**FINAL**  
**Environmental Impact Report**  
for

**IP Athos LLC's**  
**Athos Renewable Energy Project**

**(SCH No. 2018051021)**

**May 2019**

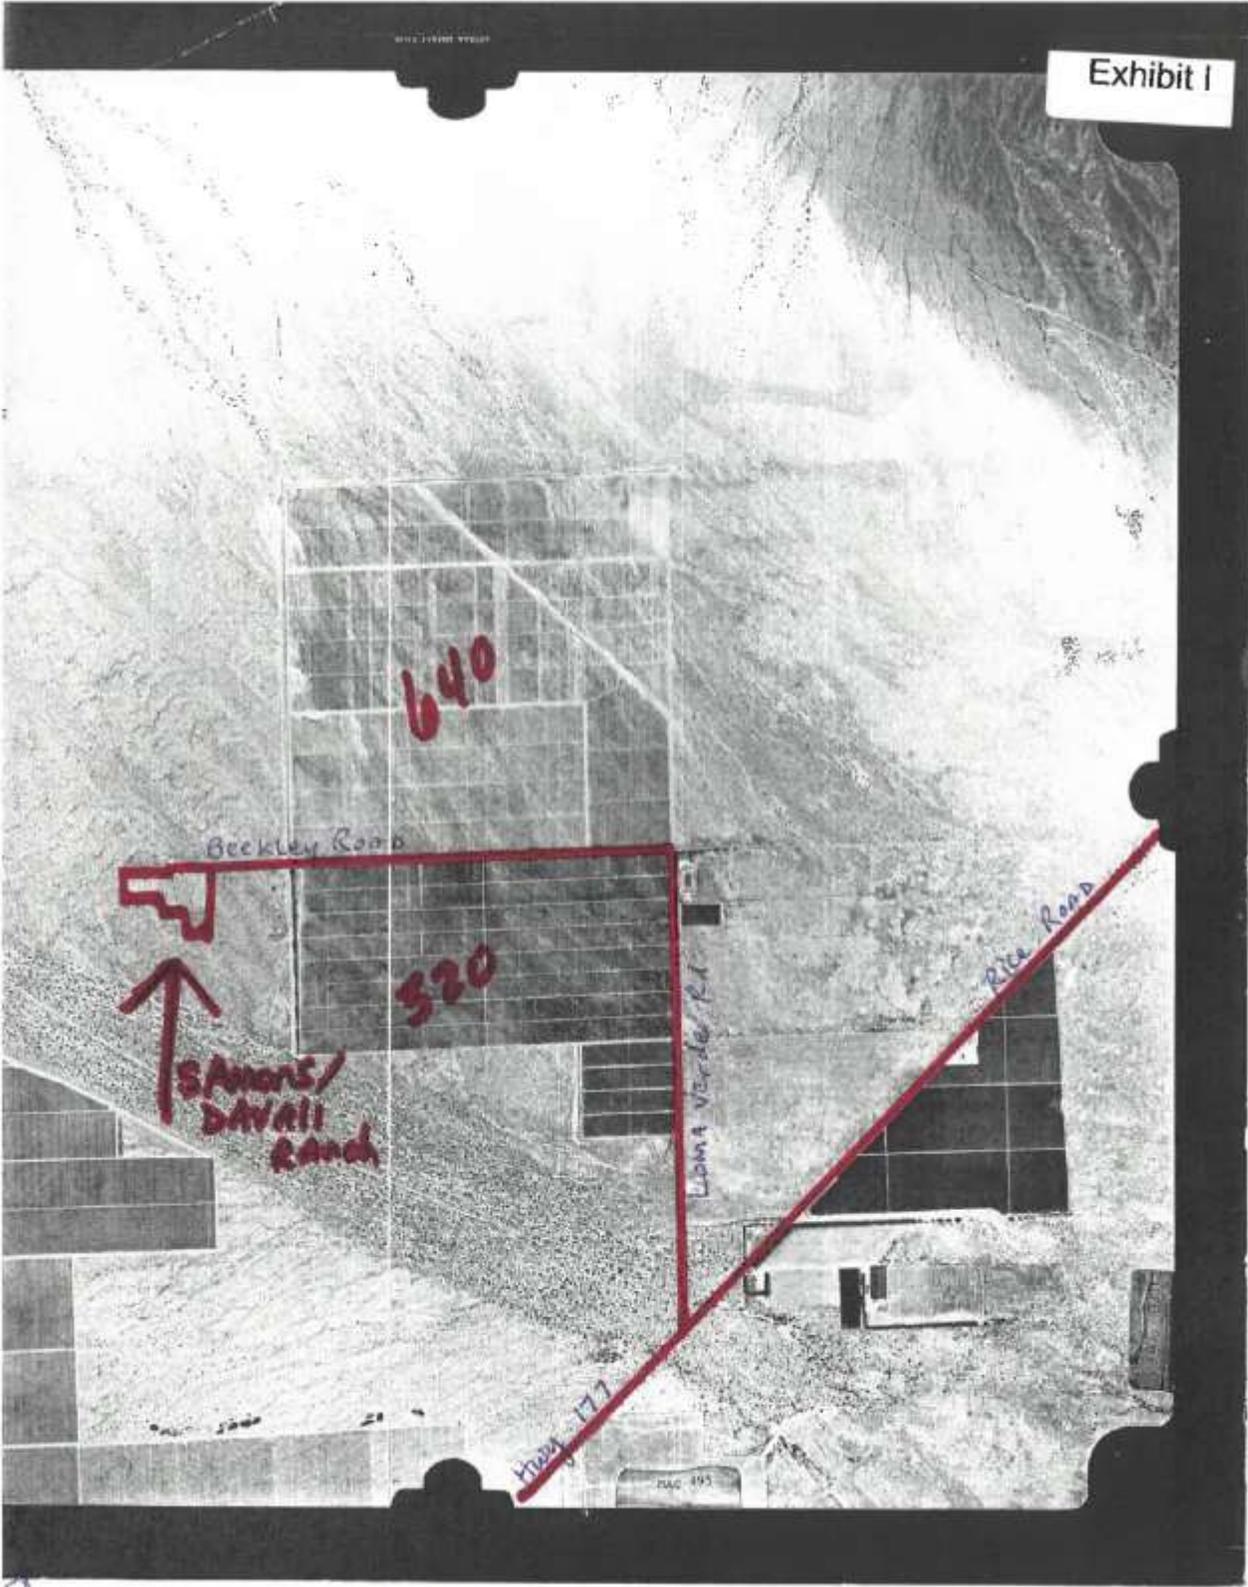
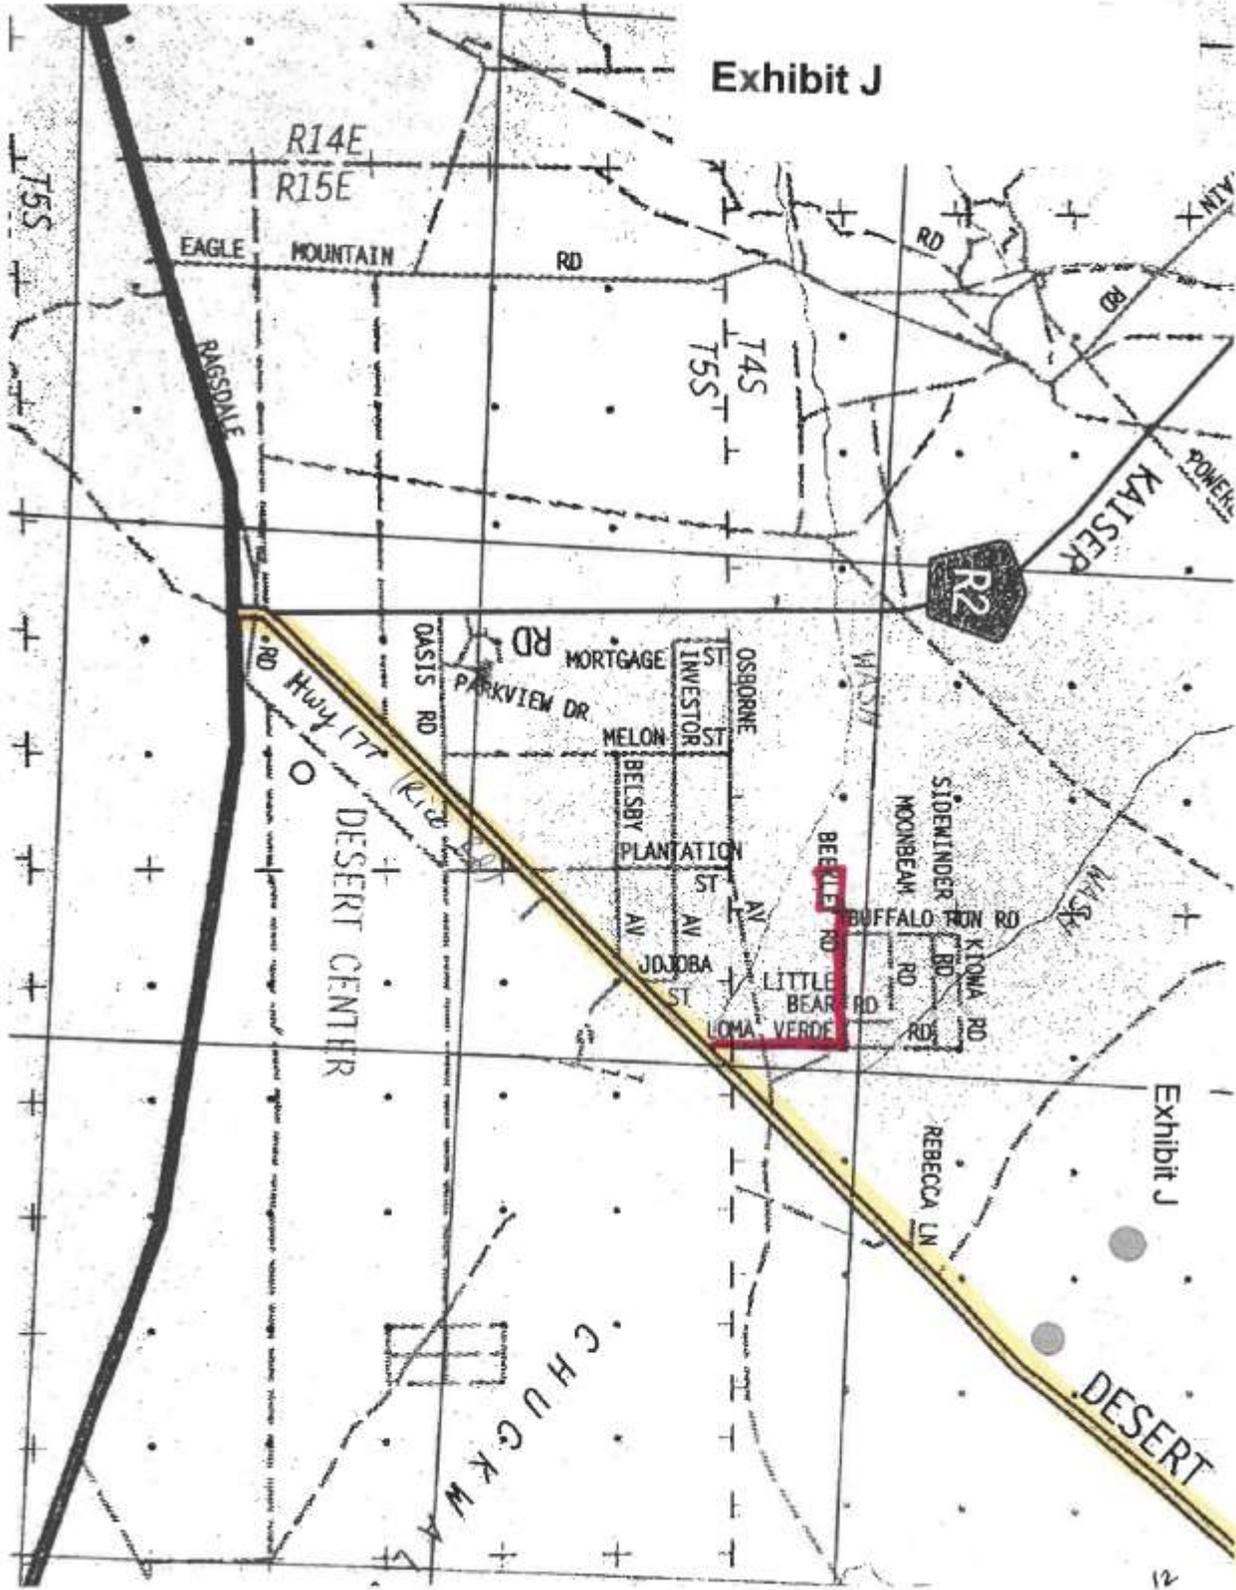
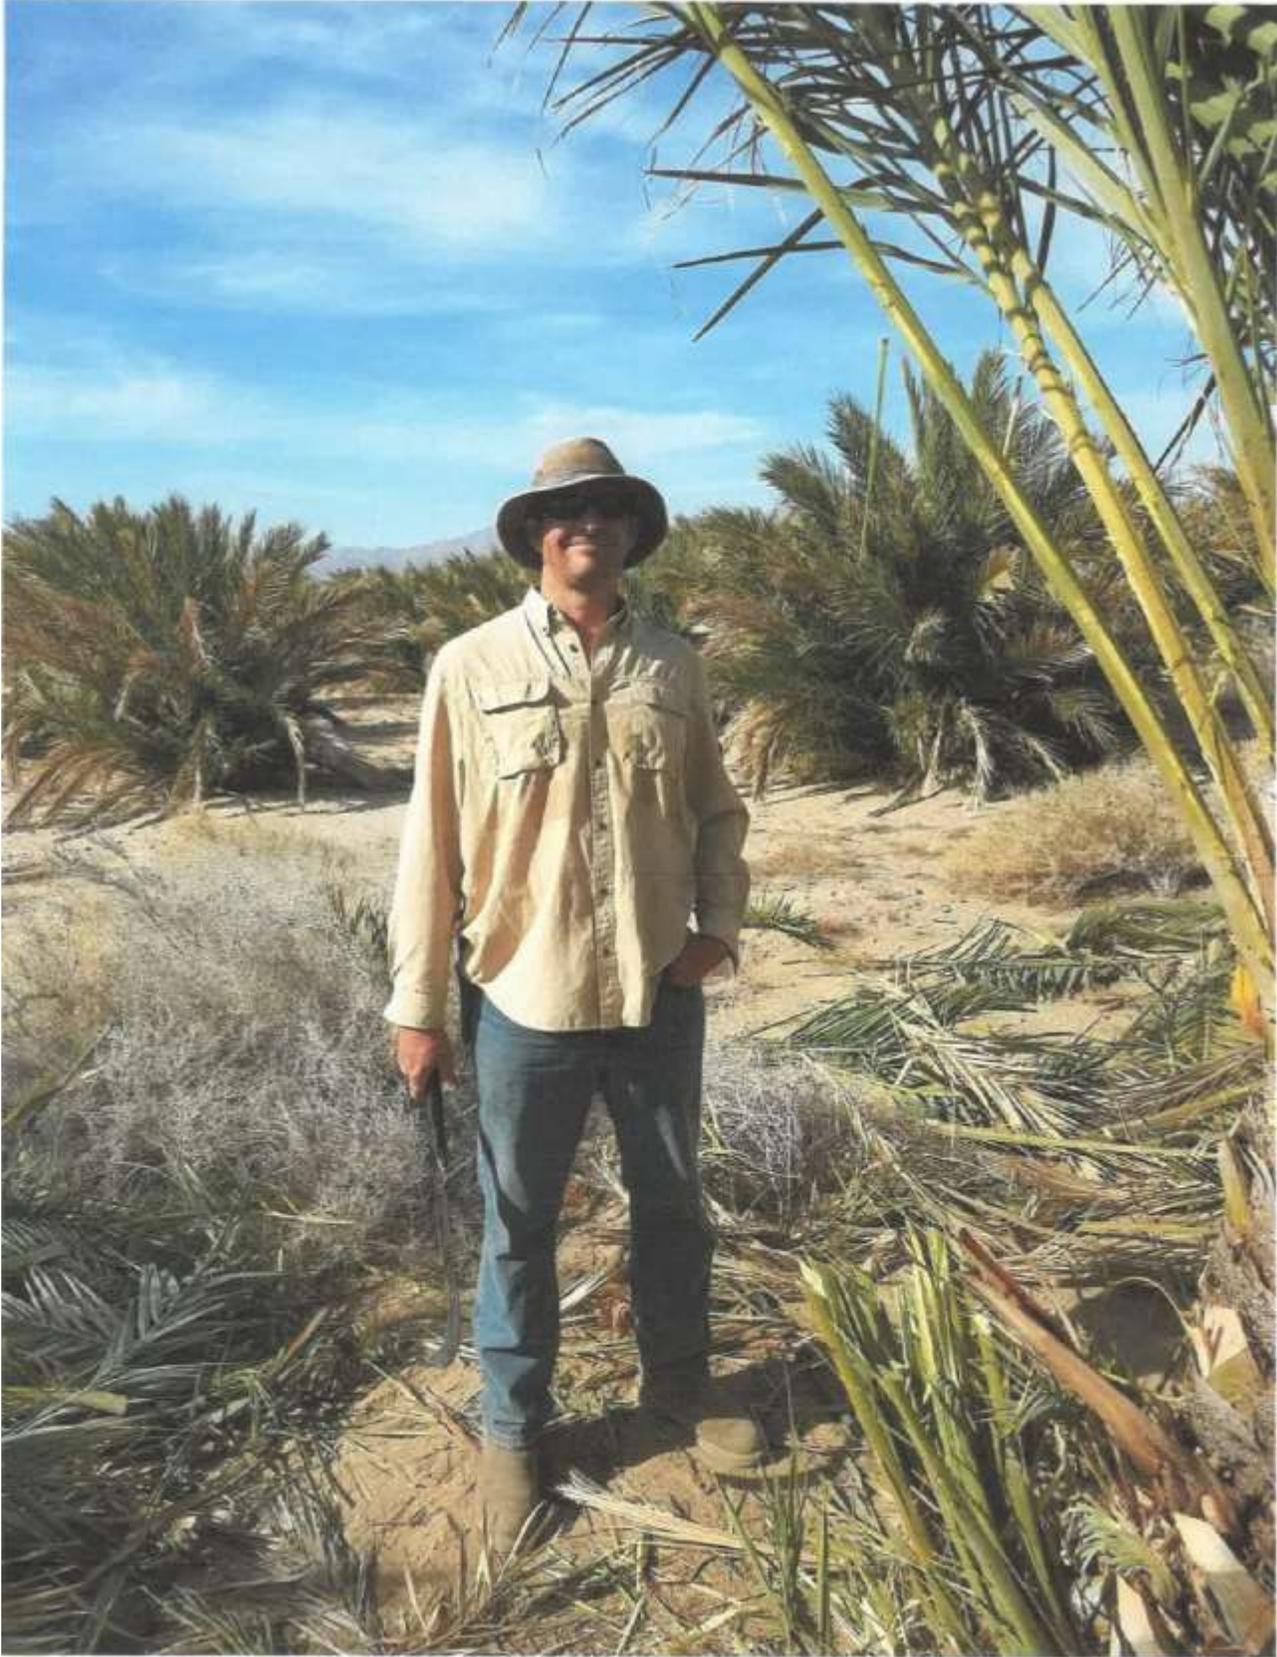
D2-10

D2-10  
cont.

D2-10  
cont.

① Loma Verde to Beekley ② out to 23025 Rice rd, Desert Center, CA

D2-10  
cont.

D2-10  
cont.
